RCRBD Record Set

Address: 43905 COUNTY ROAD 46, STEAMBOAT

TB-19-126

Character and Use: New single family residence

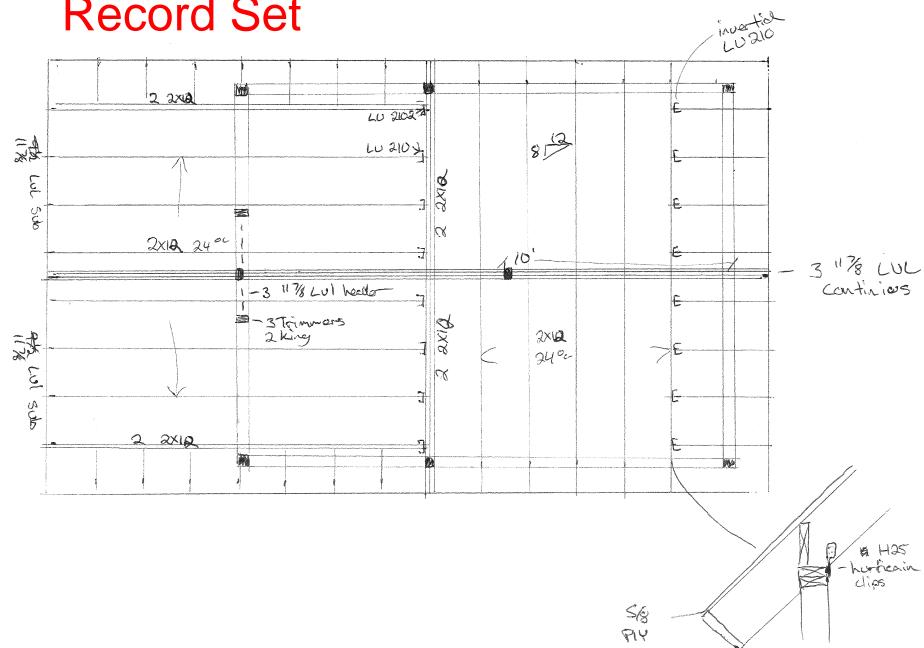
1. Page 4 of the Rosso Site Building Plan showing Building Sections and Details appears to be missing the following information:

• Foundation details such as 2x12 floor hoist with bearing details, tie-downs and support for column.

Existing and proposed grade to include relationship between finished floor elevation and existing grade. This is also important to determine pressure treatment requirements for wood.

Grade and species of lumber used (pictures indicate this may have been constructed).

3 pieces 1 ¾"x11 7/8" LVL appears overstressed. May we discuss reducing the importance of accessory structure to Risk 1 or not important such as a storage only shed?

2. Roofing details. (underlayments and roof covering materials)

- 3. Stairway construction details (material specifications, handrails) to include interior stairway may need to be removed unless it can be demonstrated to meet Appendix Q for tiny house.

Roofing industance t is high temp Grace Ice + water should under metal roofing (Roof)

Elevation Above Grade to main Floor

Tre-N-lesiter Metal Root
